Access Compliance Report

Public Rights-of-Way

Intersection ID: 44015	Main Street: ATWATER_LN	Cross Street: MANTARIO_DR	Location: W
ADA ID: 829E6DC77833	Ramp Type: PerpDiag	Initial Pass/Fail: Fail	Overall Compliance: No
		Severity Score: 42.5

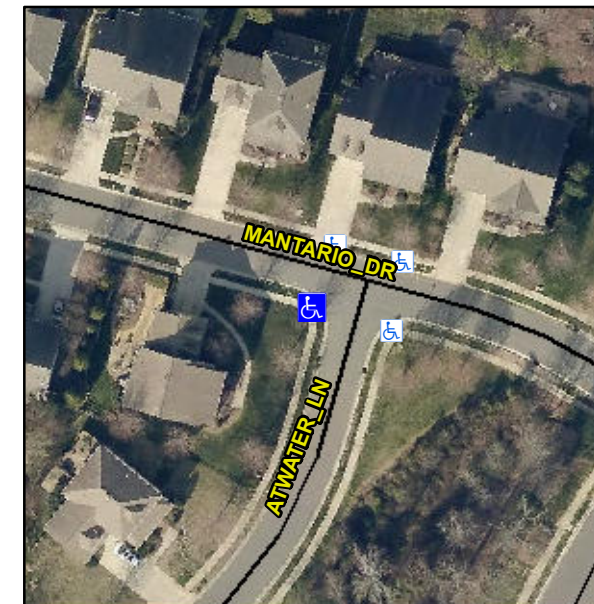
R304.5.1, R304.5.3

Compliance	Description	Data	Compliance	Description	Data
N/A	Ramp Length (in)	50.0	Yes	Ramp Slope (%)	5.6
No	Ramp Width (in)	35.0	No	Ramp XSlope (%)	8.2
N/A	Flare Type LT	N/A	N/A	Flare Type RT	N/A
N/A	Flare Slope LT (%)	N/A	N/A	Flare Slope RT (%)	N/A
N/A	Flare Traversable LT?	N/A	N/A	Flare Traversable RT?	N/A
N/A	Landing Length (in)	N/A	N/A	DWS Provided?	N/A
N/A	Landing Width (in)	N/A	N/A	DWS Contrast?	N/A
N/A	Landing Slope (%)	N/A	N/A	DWS Length (in)	N/A
N/A	Landing X Slope (%)	N/A	N/A	DWS Full Width?	N/A
N/A	Landing Curb? (Y/N)	N/A	N/A	DWS Offset (in)	N/A
N/A	Shared Landing?	N/A			
N/A	Gutter Ponding?	N/A	N/A	Gutter Slope (%)	N/A
N/A	Gutter Lip Ht (in)	N/A	N/A	Gutter X Slope (%)	N/A
N/A	Painted X Walk1?	No	N/A	Painted X Walk2?	No
	X Walk 1 Direction	To SE		X Walk 2 Direction	To NE
N/A	X Walk 1 Width (in)	N/A	N/A	X Walk 2 Width (in)	N/A
	X Walk 1 Slope (%)	3.5		X Walk 2 Slope (%)	3.1
	X Walk 1 X Slope (%)	4.5		X Walk 2 X Slope (%)	6.0

Remove & Replace Curb Ramp With Two New Directional Ramps or Equivalent.
